Report from the Nantucket Historical Commission September 2019

Milestone Road Safety and Accessibility Improvements May 2018 Construction Plan Massachusetts Department of Transportation Highway Division

The purpose of this report is to recommend adjustments to the Milestone Road Safety and Accessibility Plan, for the consideration of MassDOT and the Town and County of Nantucket, in order to preserve the scenic quality and cultural assets of Nantucket Island.

Both photos below were taken on Milestone Road

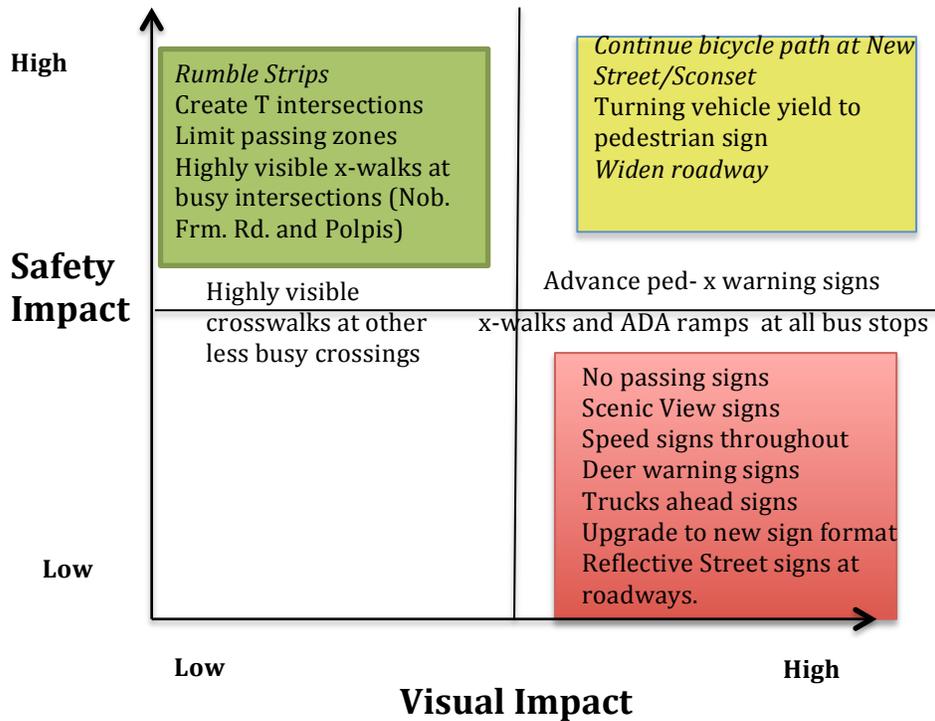
Importantly, plans appear to call for the removal of existing slanted granite curbing at Milestone Crossing and other places, and to replace it with HMA Berm.

We recommend slanted granite curb in place of HMA Berm throughout, and certainly recommend against removing existing granite curbing to replace it with asphalt.

A total of 11 intersection sites will experience some form of modification, ranging from minor adjustments to complete redesign. 16 new bus turn-outs were constructed in spring 2019. Each of these areas require new curb. Hot mixed asphalt berm is specified for curbing. We request slanted granite be used instead. Key reasons are:
